Levan Gypsum project S/023/016

Amendment to mine reclamation
plan Levan Gypsum project

S/023/016 Juab County, Utah.

Revision to Plan of Operation approved 9/20/93
Security Claims 1 - 4

MAP #2 Amended

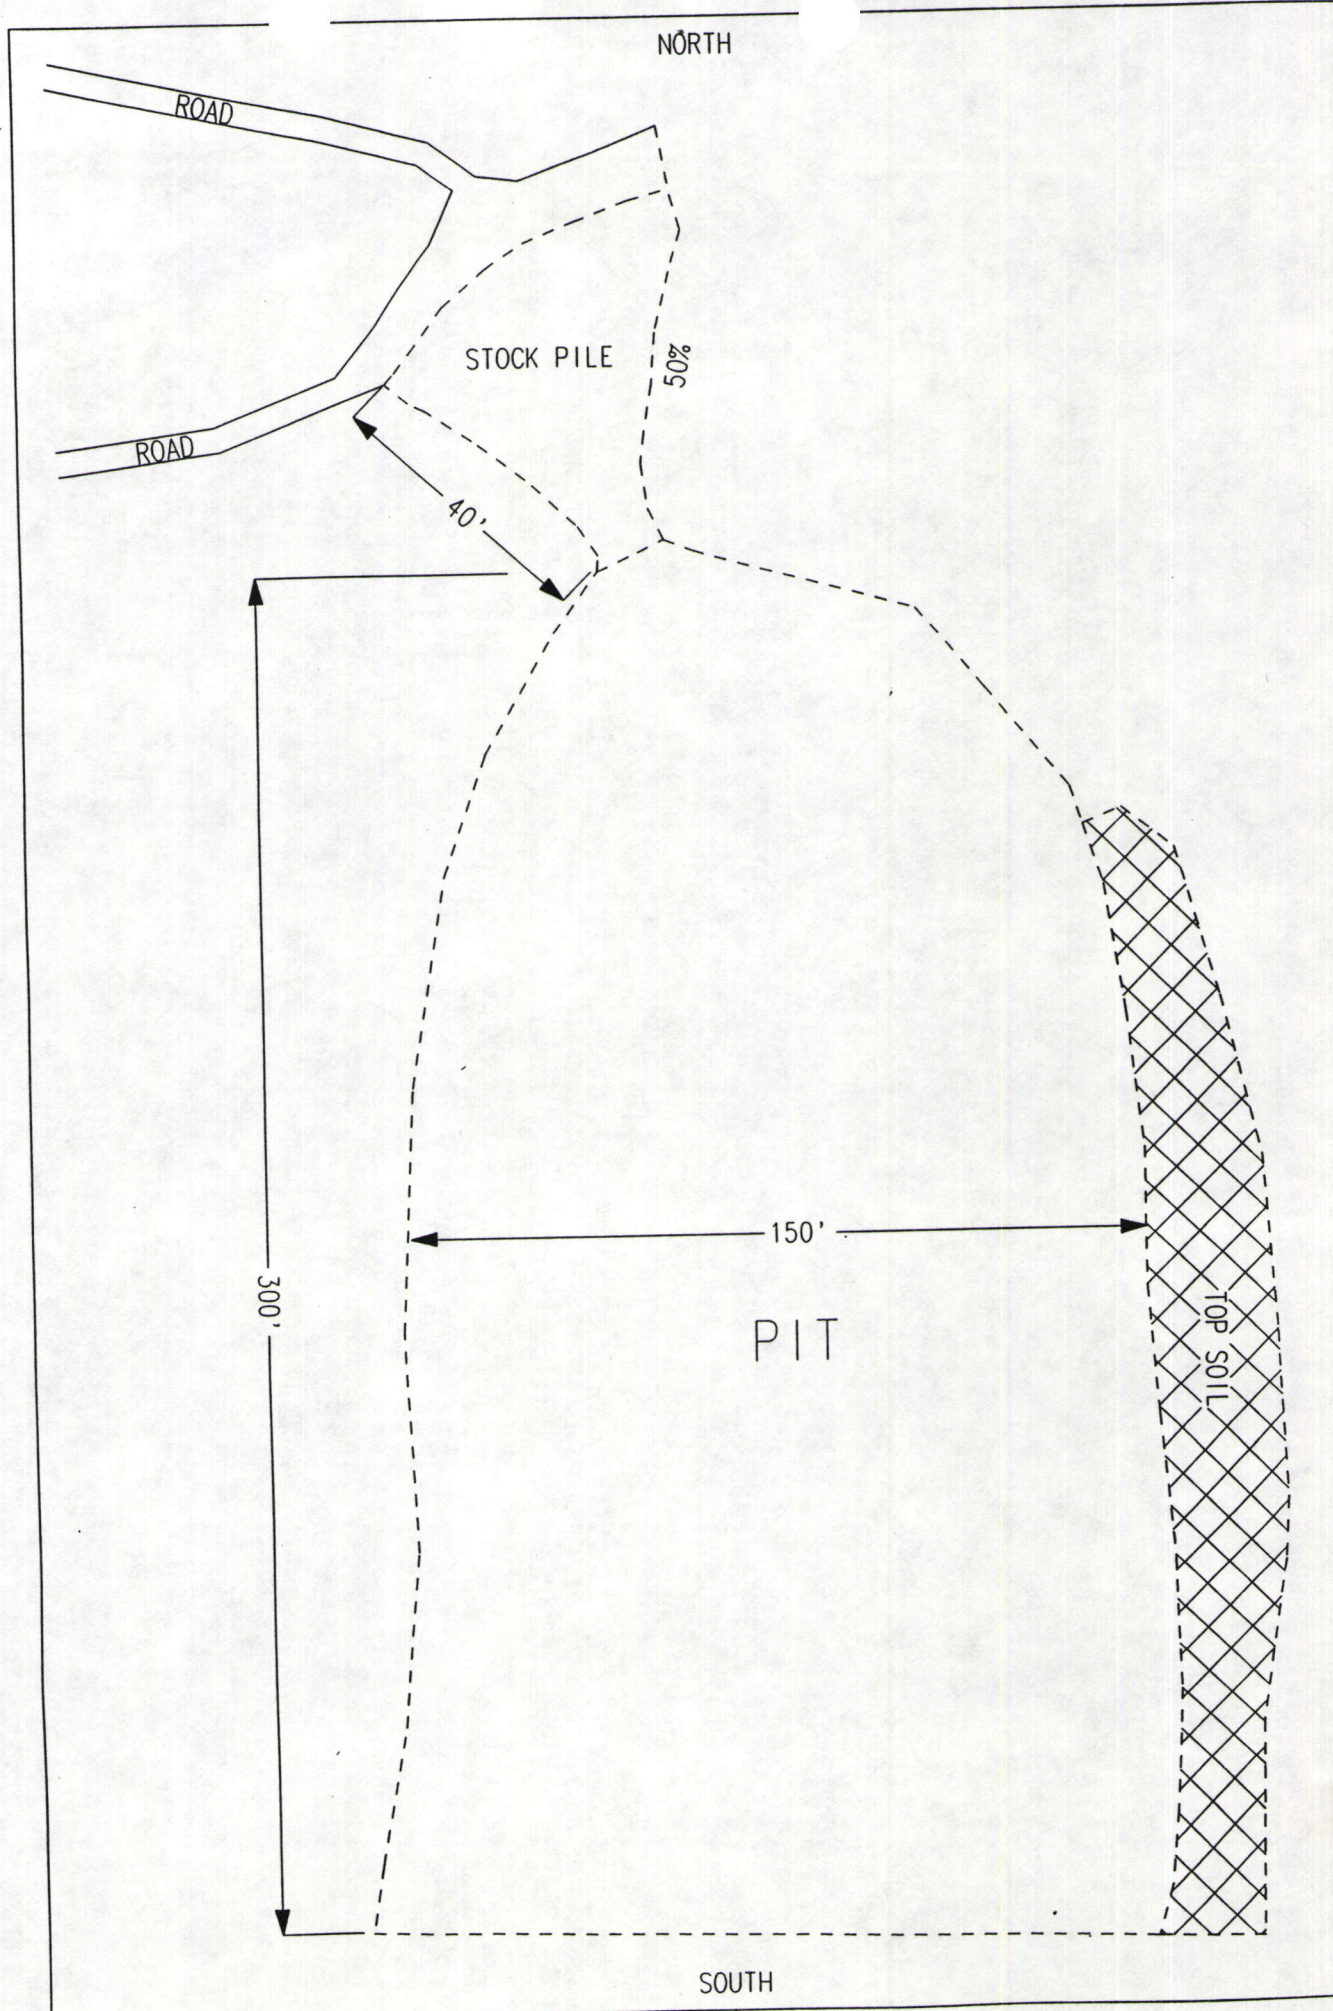
Access road to mine and stockpile
area will be constructed different
than on original maps. Map #2
amended will be the newly engineered
road and will not require
additional acreage.

MINE PLAN

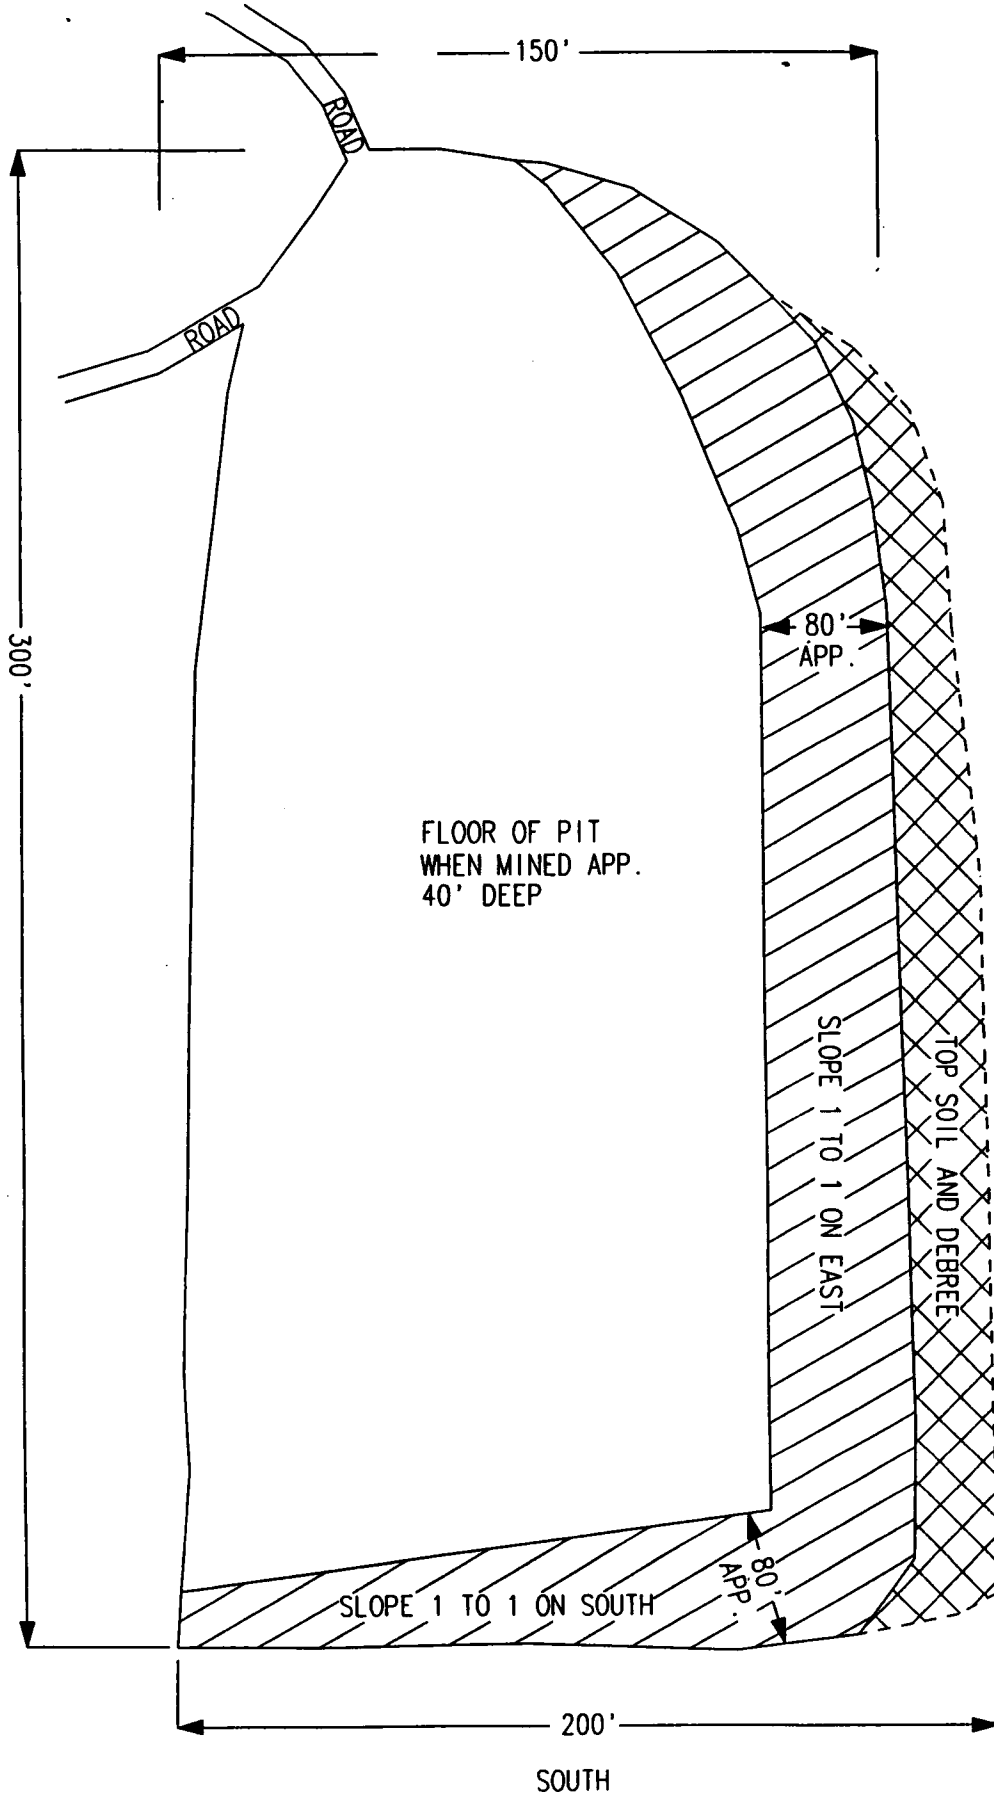
Area for Disturbance App 2 Acres
App 30,000 Tons of Gypsum will be mined and
Removed per year

- A. This revised Plan of Operations covers the development of gypsum deposits located in Security #1 thru #4 mining claims, the same as the original. Both the original and this revised plan places emphasis on recovery of the gypsum in Security #1. This revised plan is for a deposit located approximately 1000 feet west, at approximately the same elevation of the deposit described in the original plan.

The pit to be opened is 150 feet by 300 feet, which is somewhat smaller than the original. At present, the deposit in the original plan will not be developed for 10 - 15 years. The reason for the revision is to move the operation to a slope that new, specialized equipment could be used, making for less environmental disturbance and easier reclamation.

- C. All possible topsoil will be salvaged and stockpiled to the east of the pit as shown on the Mine Plan Map. Topsoil piles will be vegetated to maintain and safeguard the piles and prevent loss.

A stockpile area will be constructed to the northwest of the pit. The area will be constructed as the access road is built. Drainage will be controlled by basin behind stockpile area. The drainage area above the stockpile area is small and heavily wooded.

SCALE: APP. 1' = 25'

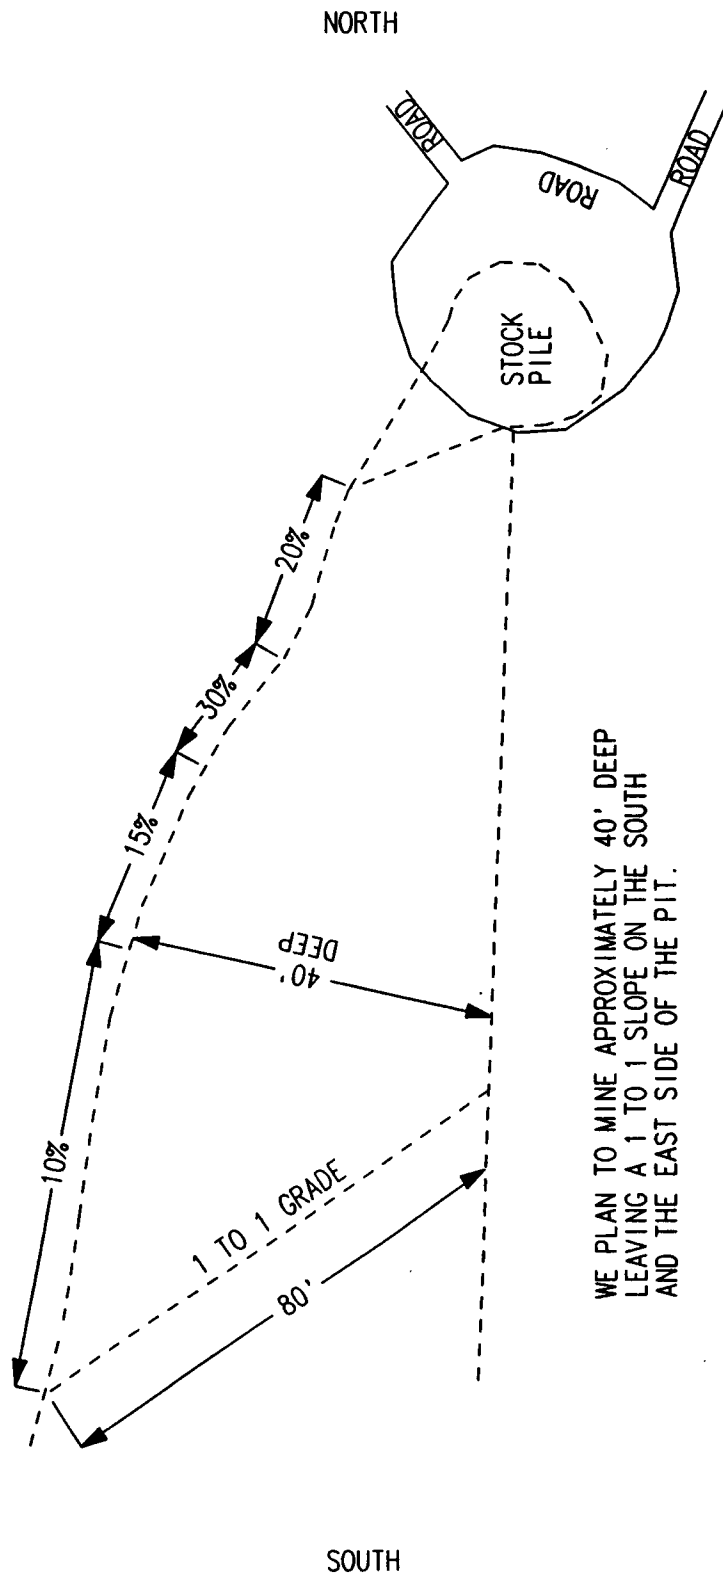
WE PLAN TO MINE APPROXIMATELY 40' DEEP
LEAVING A 1 TO 1 SLOPE ON THE SOUTH
AND THE EAST SIDE OF THE PIT.
